Change Order Form

Project Title: Cascade Falls Aquatic Center						
city of	Contractor:			 Construction 		
Ankeny	Address:			Humboldt, I		
bringing it all tagether		24.2924.4412		inance Proje	-	924.4412
aringing it all ingriore	Vendor Project or Invoice #:		9-046		PO #	
	Original Contract Date:	April 6, 20	009	Ven	dor#	6374
Change Order Number:	4					
Change Order Date:	January 21, 2010					
Purpose of Change Order:		n n : 1:				ale was alotaila in

REQUEST FOR PROPOSAL

Project:	Cascade Falls Aquatic C	enter	Request for	Proposal (RFP) No.: 5	
	Ankeny, Iowa		From: <u>Melir</u>	nda Fridy, Water's Edge Aq	uatic Design
То:	Joel Armitage		Date: Octob	er 23, 2009	
	Sande Construction		WEAD Proj	ect Number: 08-516	
Re:	Lazy River Wall Revision	ons			
You are consider	hereby directed to review that a change in Contract	this Request for Proposal Time is required, submit t	(RFP) and prepare and he requested time extens	submit a fixed price quotation with your quotation.	ion within 10 days. If you
	otation shall remain valid opportunity to re-evaluate		If Owner does not acce	pt the proposal during that	time period, then you will
Specific	ation Section:	Paragraph:	Drawing R	eference: SP-P13,

SP-P13.31

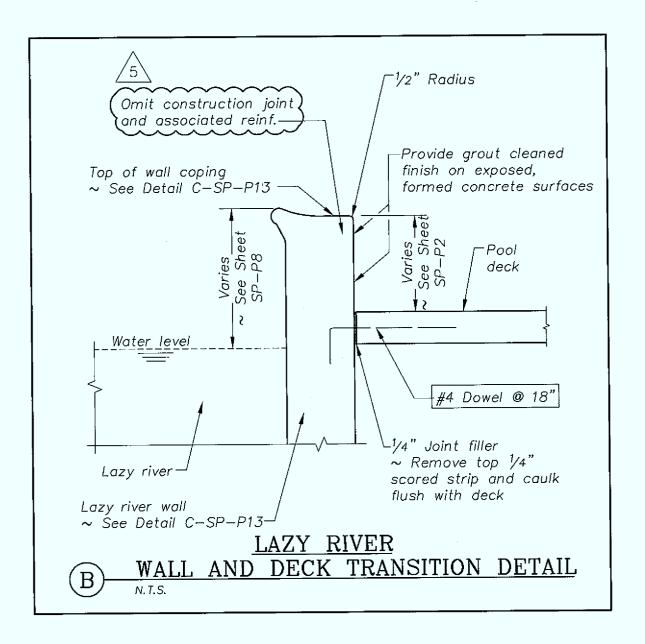
RFP #5 (10-23-09) ~ References Detail C-SP-P13 Description of modification: Modify lazy river wall detail

1. Modify the lazy river wall so t	the top coping is monolithic with	tne wall in liet	ı or m	onolitnic with t	ne poor de	ck per details in
RFP #5. No additional cost or	credit for this change. veillance system in lieu of the sp	osified digital	 cucto	m nor PED #6	Drovida ti	ne Owner a credit
in the amount of \$665.00.	veillance system in lieu of the sp	ecined digital	Syste	in per ixir #0.	LIONIGE D	le Owner a credit

SP-P22.32

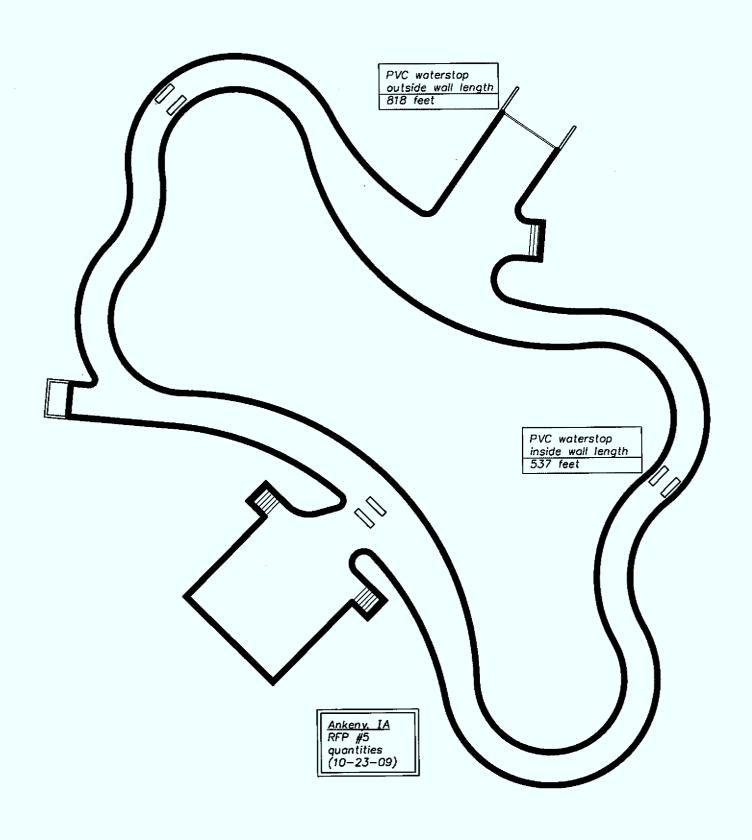
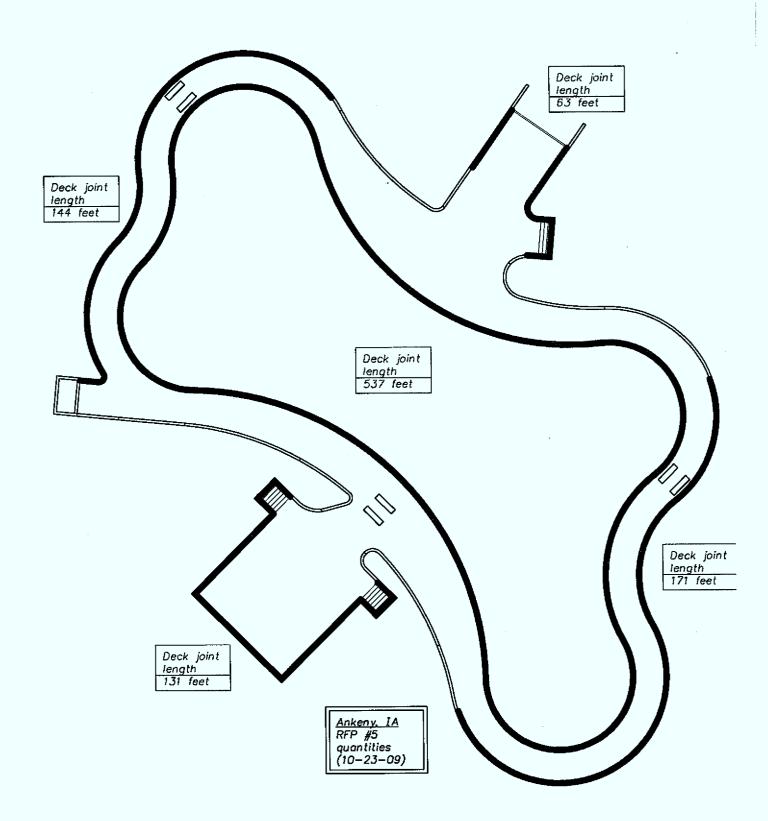
RFP #5 (10—23—09) ~ References Detail B—SP—P22 Description of modification: Modify lazy river wall and deck transition detail
